## City of Portland, Maine - Building or Use Permit Application 389 Congress Street, 04101, Tel: (207) 874-8703, FAX: 874-8716

10 Exchange St.

10 Exchange Street - Portland Maine Building Permit #032-1-12

Intercommunicating stair to basement

ACTION OF OPENING AT WALL FOR STAIR

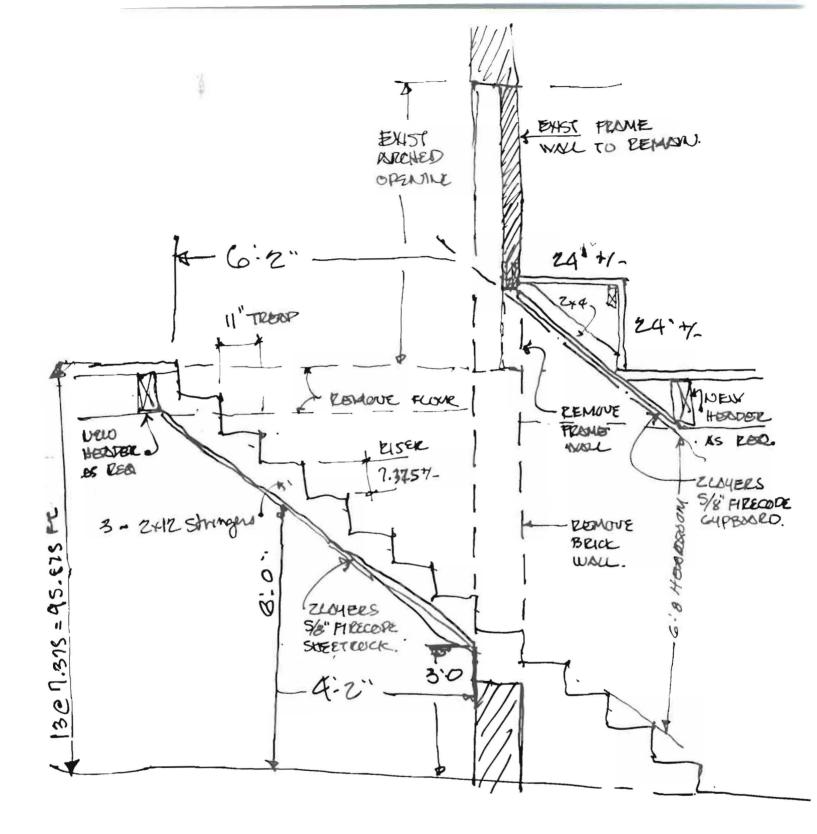
1
Z-17-00 An inexchap determined The world was lead Basen in such a
Z-17-00 An inspection determined The wall was lead Bearing - Issued a  Stop Work Order - need further ammendment to continue. YB  HTSO speak to contractor about 7"×11" Rise/Run 4 minimum 36" width of opening JB  4-20-00 NOW Derinit Issued JB
Stop Work Order - need turker ammendment to continue. 16
1750 Speak to Contractor about 7"x11" Rise/Run of minimum 36" with of opening AB
4-20-00 Alous Deamit 135/100 B
The following parties of the following parties
•
Inspection Record
Type Date
Foundation:
Framing:
Plumbing:
Final:
Other:

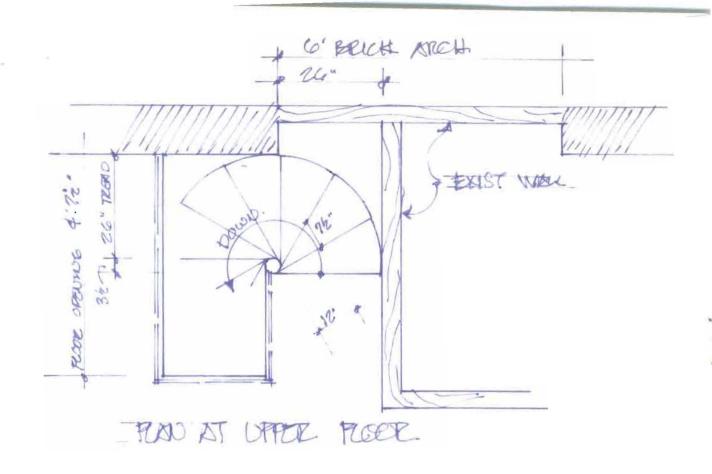
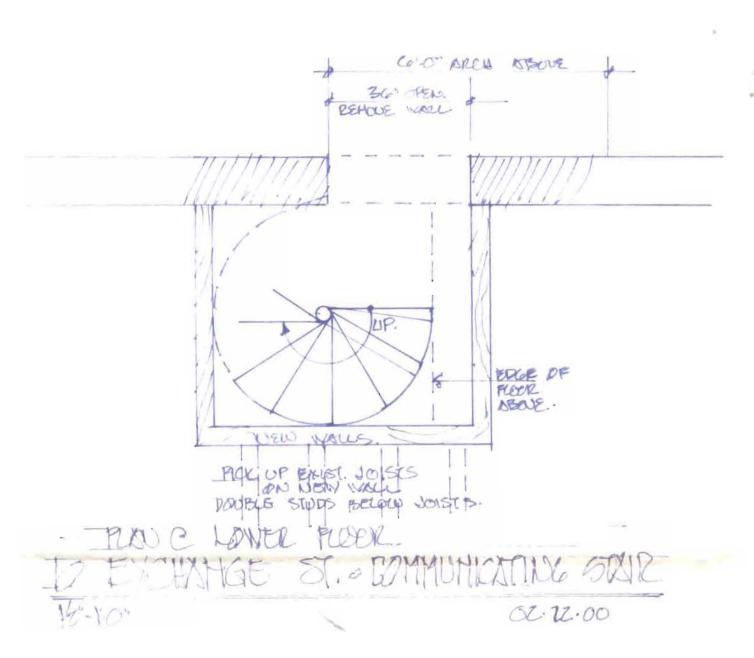
I am including a revised plan of the proposed stair at the Hemp Shop at #10 Exchange street. As you know the previous stair was declared to be to narrow (25.1 to meet the 35 code requirement.)

We have also shown the horizontal opening through the brick wall to be 36 wide and the entire 36 is below the arch above therefore carrying no wall load. The joists interrupted will be carried by the new wall build to close off the stair area from the adjacent shop.

The present proposal is for a spiral intercommunicating stair which meets the requirements of (BOCA 1014 5 and figure 1014 5 4) for spiral stairs

The code states that the stair cannot be used as a means of egress and as it does not serve as a means of egress it should be OK. The code states that "like stairways with winders spiral stairs may be used in any occupancy as long as such stairs are not a component of a required means of egress. Also the winders section 1040 6 104150 states. This section does not prohibit winders and by the reference mentioned above spiral stairs) from being used in stairways that are not a required means of egress.
